AGENDA
CITY OF CEDAR FALLS, IOWA
PLANNING AND ZONING COMMISSION
WEDNESDAY, SEPTEMBER 12, 2018
5:30 PM AT CITY HALL - COUNCIL CHAMBERS

TO: Planning & Zoning Commission
FROM: David Sturch, Planner III
Jon Resler, City Engineer
DATE: September 6, 2018
SUBJECT: Park Ridge Estates Preliminary Plat

Park Ridge Estates Preliminary Plat

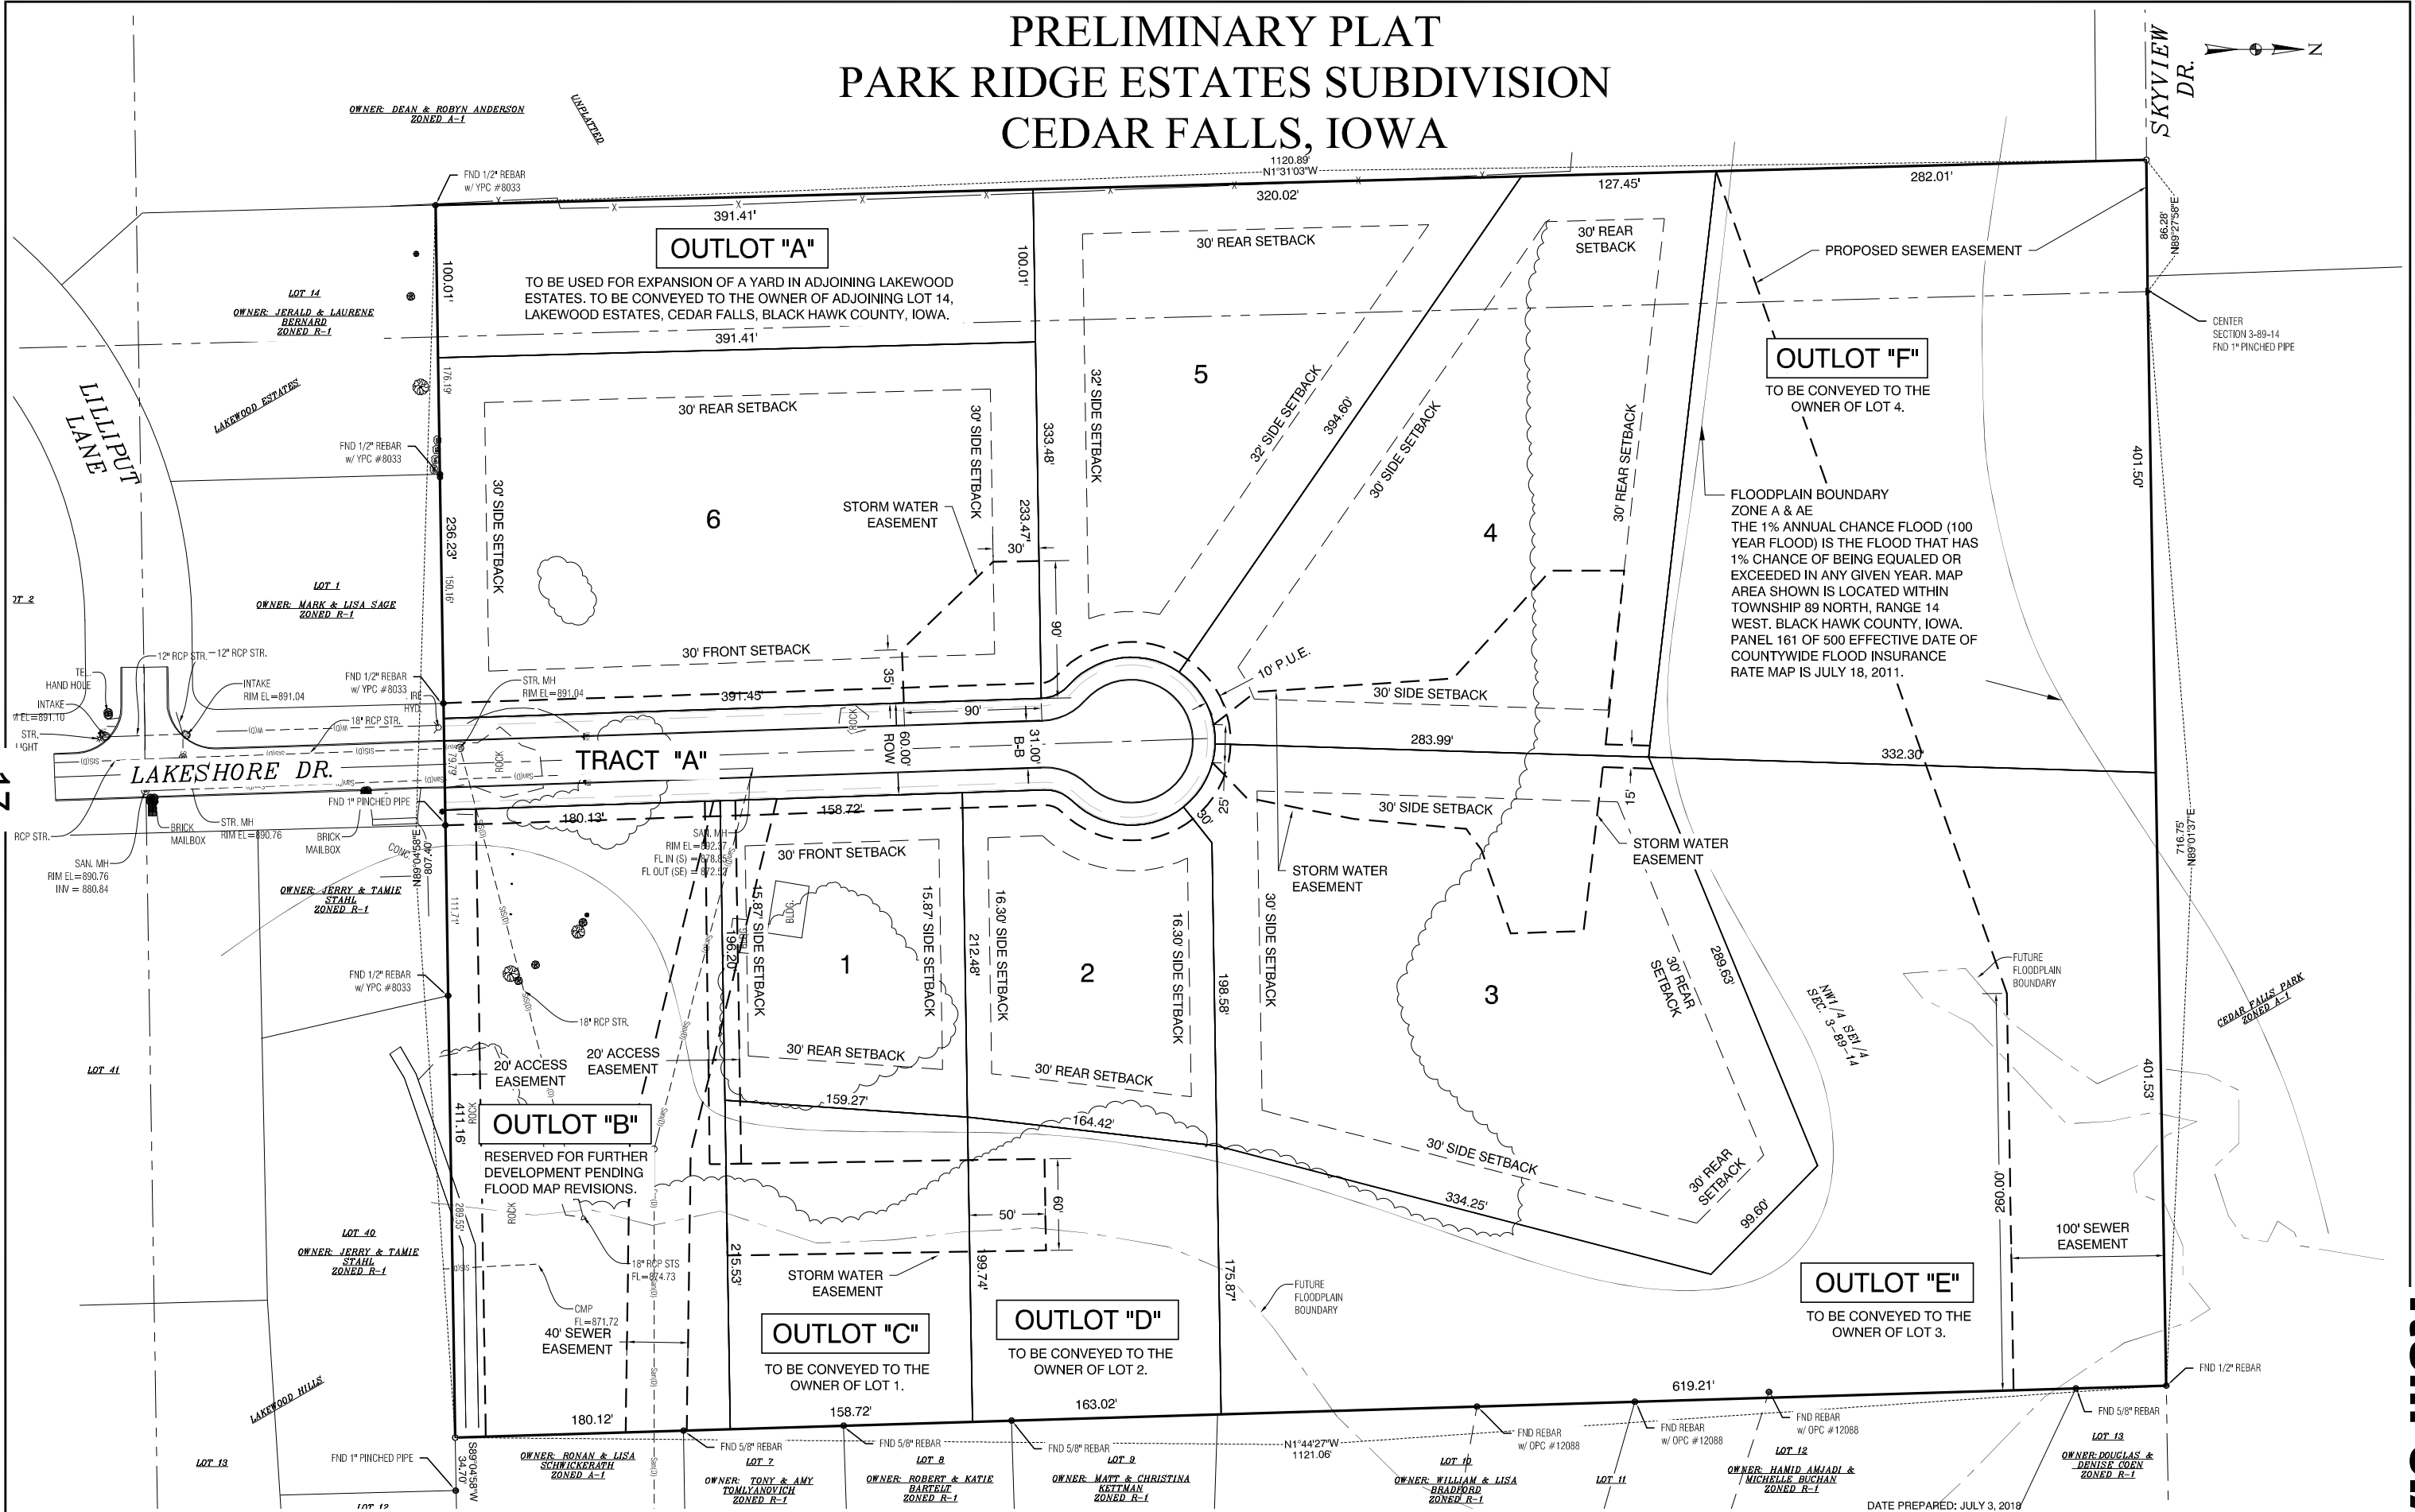
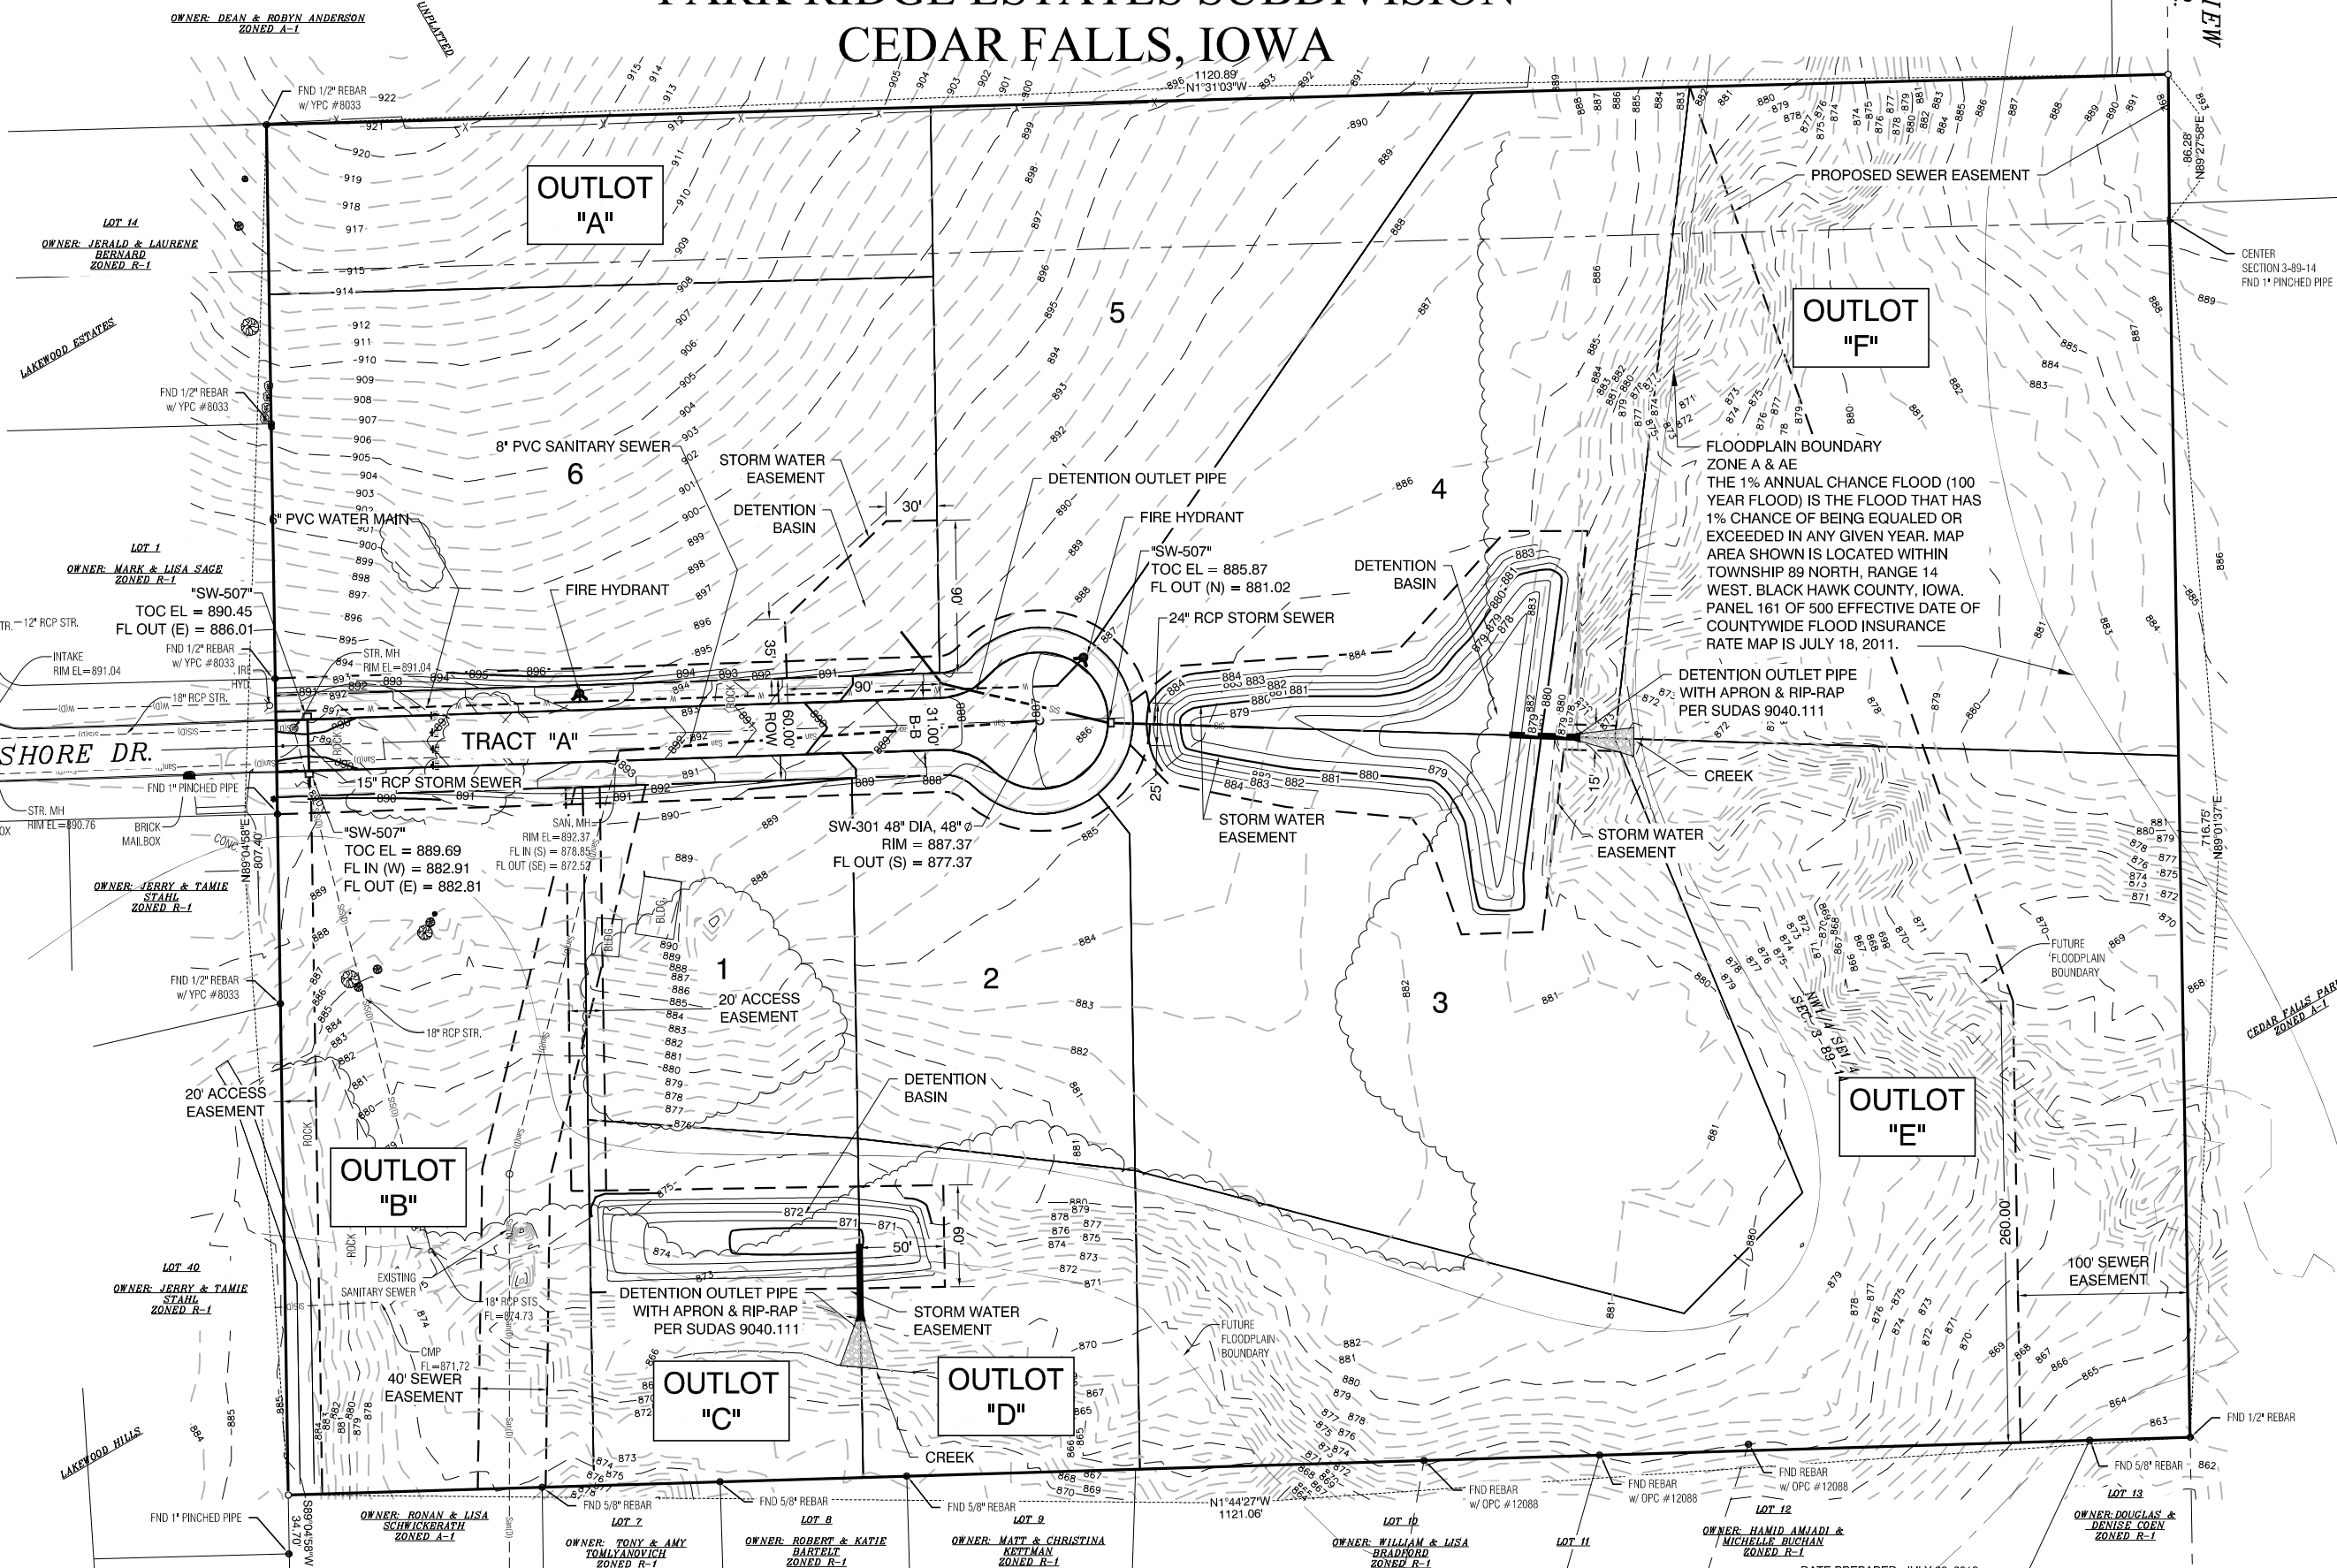
A storm water detention plan has been reviewed and approved. Approximately 1/3 of the southwest portion of the plat will drain into the storm sewer intakes in Lakeshore Drive. From here, the storm water will be carried in an existing pipe to the east end of Outlot B and empty into the ravine along the east side of the plat. This ravine meanders in a northeasterly direction and eventually connects into the Cedar River. The rest of the lots in the subdivision will drain to the east and north into detention basins located on Outlots B and C and Lots 3 and 4. These basins will be designed to detain the 100 year storm flow and have a controlled release into the ravine along the east and north side of the subdivision. These storm water basins will provide a better way to collect and release the storm water than the existing uncontrolled flow. Therefore, the entire site will have a net discharge rate in compliance with the Cedar Falls stormwater detention requirements. Drainage easements are provided along the north and west edge of the site to channel the water into the proposed detention basin. The subdivision must be designed so that it is clear who is responsible for long term maintenance of the stormwater facilities. Staff is concerned with the current proposal that extends the two basins across the private lot lines, which will make it difficult to define responsibility for maintenance of these facilities over time. When there is confusion or misunderstanding about such matters, it often falls to the City to address the issue. To prevent such a situation, each stormwater basin should be placed within a separate outlot or tract, and the responsibility for maintenance set forth in the legal papers. Typically such maintenance is assigned to a homeowner's association so costs are shared between all the owners within the subdivision, rather than just a few. Staff recommends modification of the proposed plat to address this issue. A legal description of these stormwater basins should be identified on the plat. Staff notes that some lot lines may need to be adjusted slightly to ensure that lot width standards are still met for the two lots at the end of the cul-de-sac.

The sanitary sewer will be extended to the north end of Lakeshore Drive to service each lot. Typically, the sanitary sewer must be extended to the limits of the plat, per the City's subdivision

ordinance in order to accommodate the future growth in the northwest portion of Cedar Falls. The petitioner's engineer provided a preliminary sanitary sewer study to identify a future location of the sewer extension to the limits of the plat. It was determined that due to the steep slopes, floodplain and soil conditions, a sanitary sewer is not feasible through the north end of the Lakeshore Drive extension or along the easterly property line. Therefore, the proposed development of this property will utilize the existing lift station at the southeast corner of the property. The plan is to extend a future sanitary sewer to a new lift station in Ulrich Park, north of the proposed subdivision. This sewer line will continue through the north edge of this plat to service future growth in western Cedar Falls at some point in the future. A sanitary sewer easement will be established along the north side of the plat to allow for the future extension of the sanitary sewer.

1. The cul-de-sac must have a 45-foot wide radius for 90 feet of pavement.
2. Place the stormwater detention basins in a separate outlot or tract with legal descriptions.
3. Each lot must comply with the lot width standards for the R-1 zoning district.
4. Provide a riparian easement for the future use of Outlots B, C, D, E and F.
5. Conform to all city staff recommendations and technical requirements.
6. Provide a revised owner's Deed of Dedication.
